COTTAGE ROAD PEAKS ISLAND
92-E-47 (Sterling Row)

APPLICATION FOR PERMIT

To construct roof over existing porch 25.2' long x 6' wide on side of cottage.

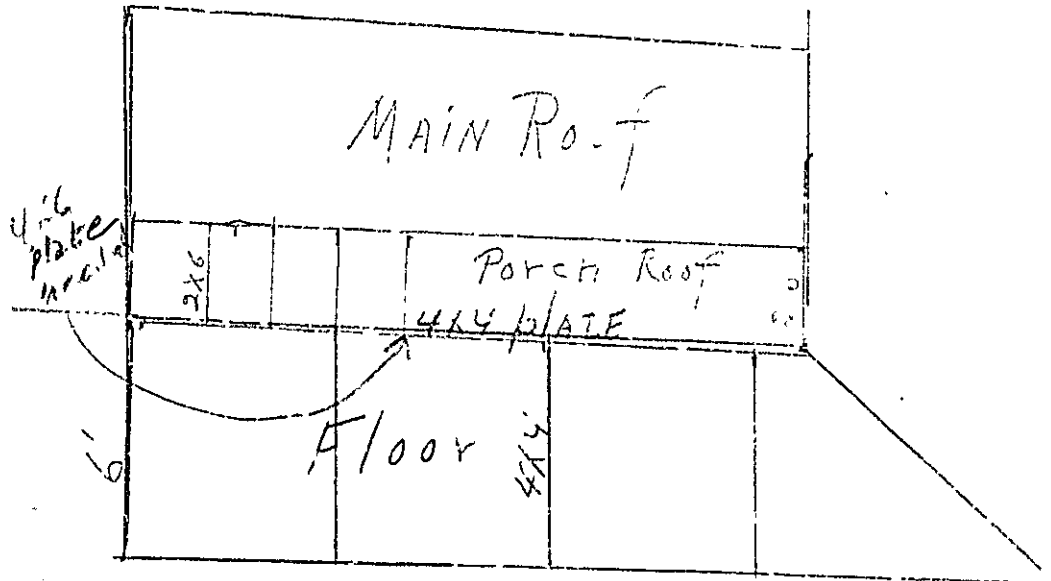
Permit to construct roof over existing porch 25 1/2' long by 6' wide on cottage is being issued subject to the following Building Code restriction that the plate that is to support the roof load on a 6 foot span will be at least a solid 4" x 6" member instead of the 4x4 inch plate shown on the plan.
